#### **CERTIFICATE OF APPROPRIATENESS**

Property: 1626 Cortlandt, LT 20 & TR 19A BLK 115 Houston Heights

**Proposal:** Alteration – Addition

ITEM B3 1626 Cortlandt Street Houston Heights East

Figure 5 - These 2 Images Illegal Side Addition to Be Removed

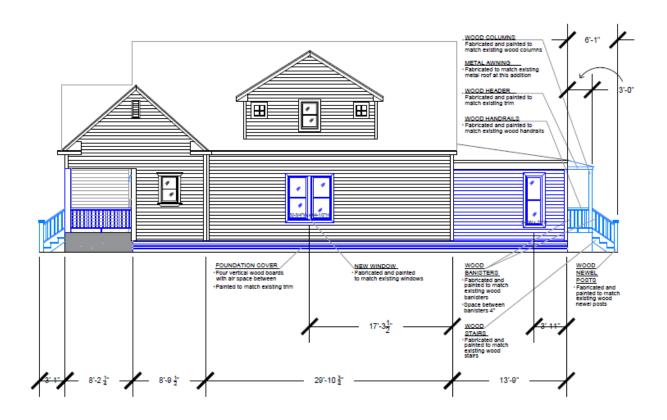
Work completed without COA, rough framing of a side addition on the south elevation.

- To remove the rough framed side addition and instead make conditioned space in existing rear facing back porch.
- Proposed alterations to front elevations, see drawings
- House has a mix of vinyl and cementitious siding, residing will be done in smooth cementitious siding.
